**HVAC SYSTEMS AT HARRISON MEMORIAL & PARK BRANCH LIBRARIES
INVITATION FOR BIDS 18-19-002**

ADDENDUM #1

Date of Addendum: 11/08/18

Attachment #2: Alternate Route of Refrigerant Line

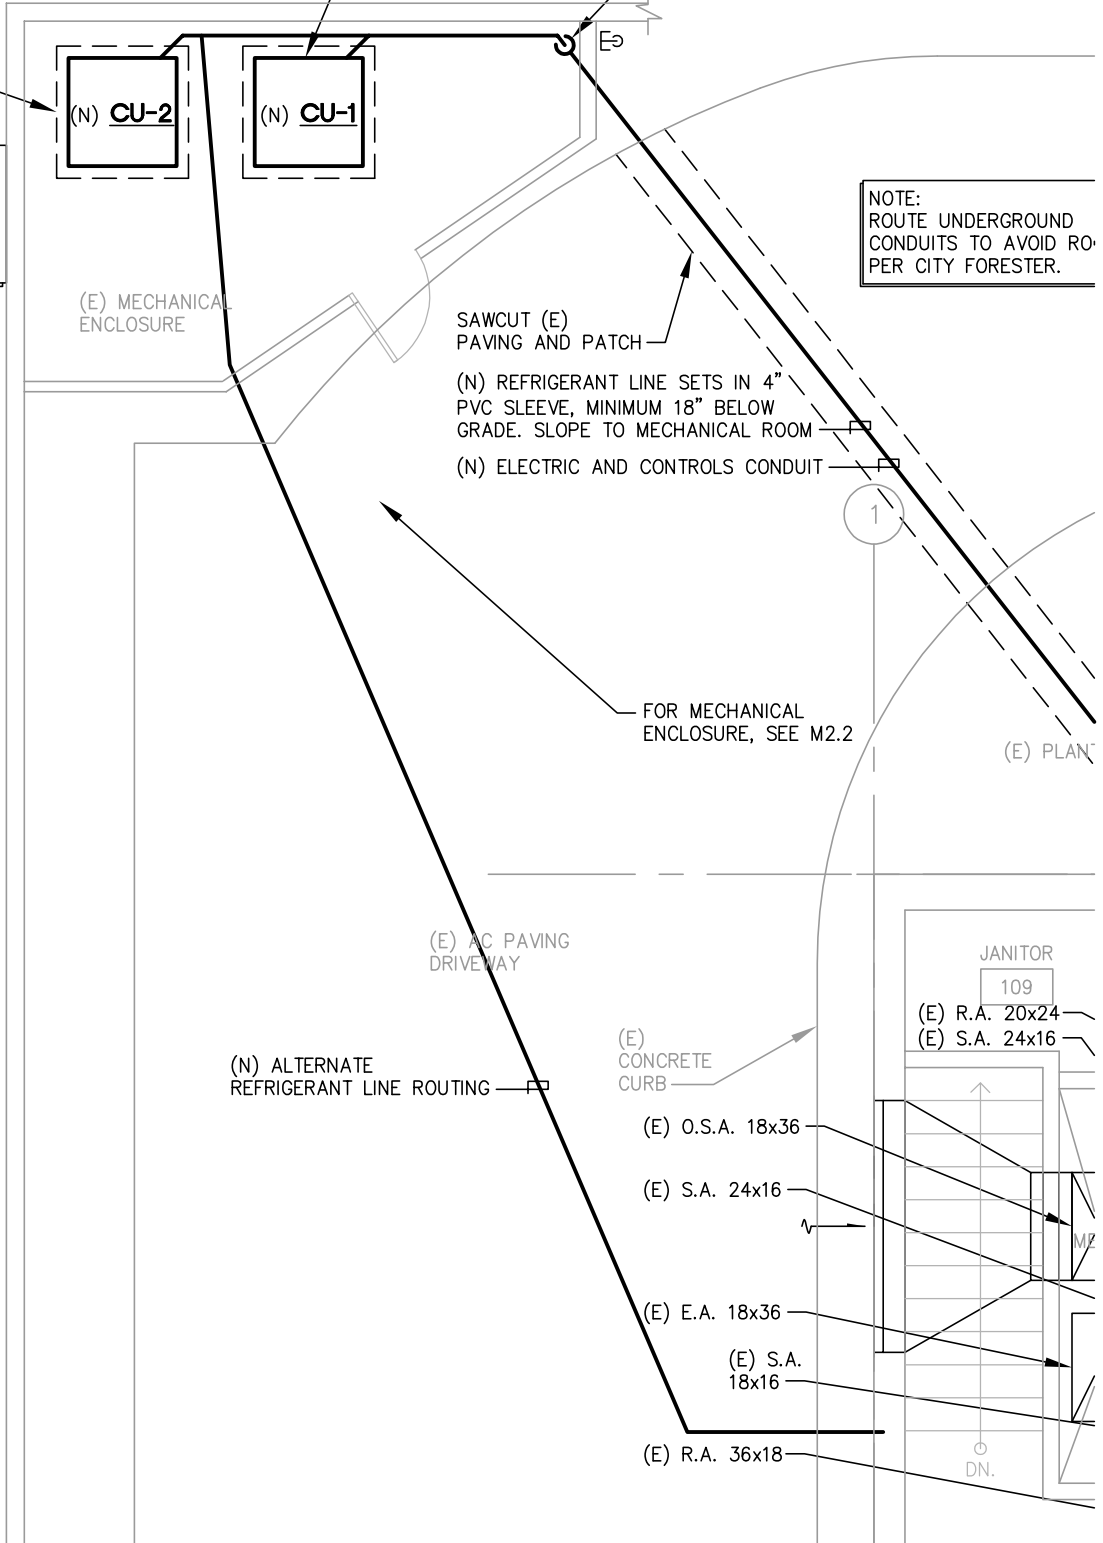
Item	Questions and Answers
2.01	<p>Question: Who is responsible for providing the duct detectors and wiring the duct detectors to the fire alarm panel?</p> <p>Answer: The contractor is responsible for providing the duct detectors and wiring the duct detectors to the alarm panel. Include the cost for this work in bid items 3 and 4. (See Revised Note 11 on Sheet MO.1.)</p>
2.02	<p>Question: The refrigerant line routing shown on sheet M2.2 was questioned as to maintaining clearance over the walkway at the bottom of the stairs.</p> <p>Answer: Maintain head clearance when routing through the stairwell, or re-route out through north wall similar to existing refrigerant line detail. See Attachment #2, Alternate Route of Refrigerant Line.</p>

RISE WITH LONG SWEEP ELBOW AND SEAL AT GRADE

NOTE:
PROVIDE NEW DISCONNECTS CONDUIT AND CONDUCTORS BACK TO DISCONNECTS IN BASEMENT MECHANICAL ROOM

NOTE:
ROUTE UNDERGROUND CONDUITS TO AVOID RO PER CITY FORESTER.
